**North Rockland High School Projects – Phase 2**

**MSA File No. 43045**

**NOTICE TO BIDDERS**

Re: **ADDENDUM NO. 1**

UTILITY PLAN -  
SOFTBALL FIELD

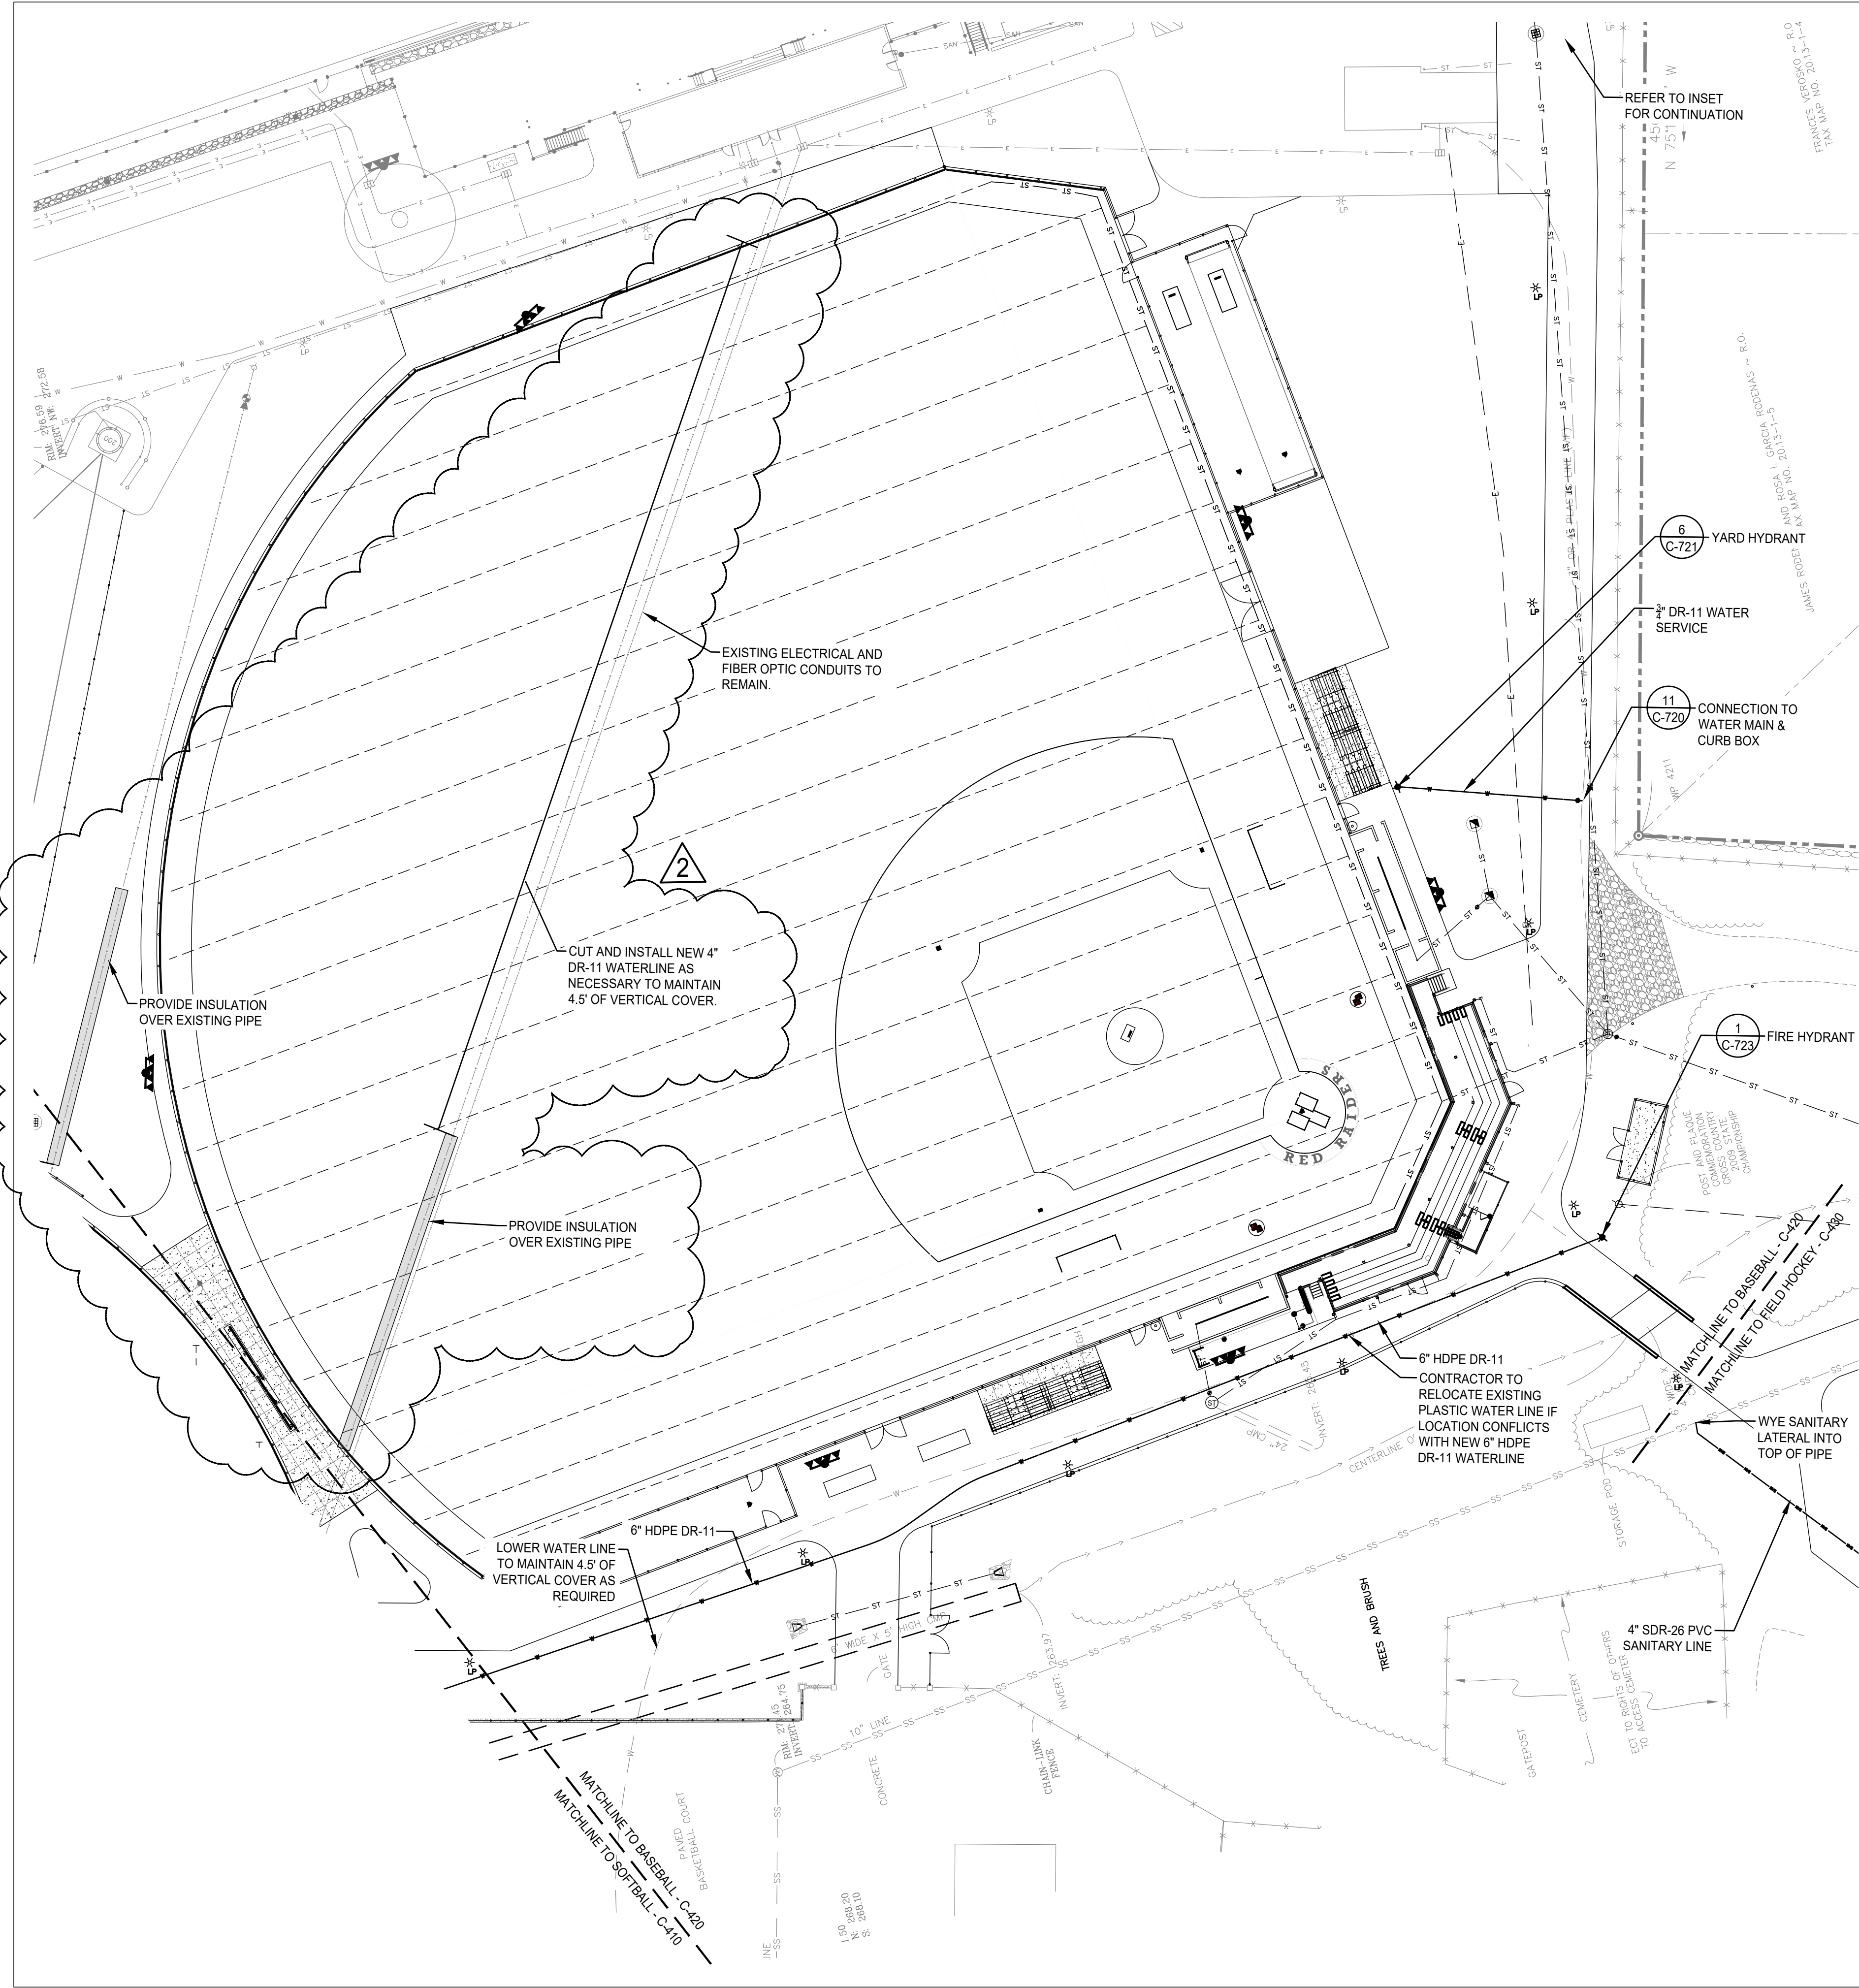
Please see revisions to drawings C-410, C-420, and C-720 for locations where changes in grade will require existing active 4" and 8" water lines to be lowered to maintain proper burial depth. Bidder shall carry cost in base bid to cut and replace sections of 4" and 8" water lines in areas shown. Bidder shall also carry cost in base bid for adding insulation over existing water lines where shown. Existing detectable warning tape shall be replaced in all disturbed locations.
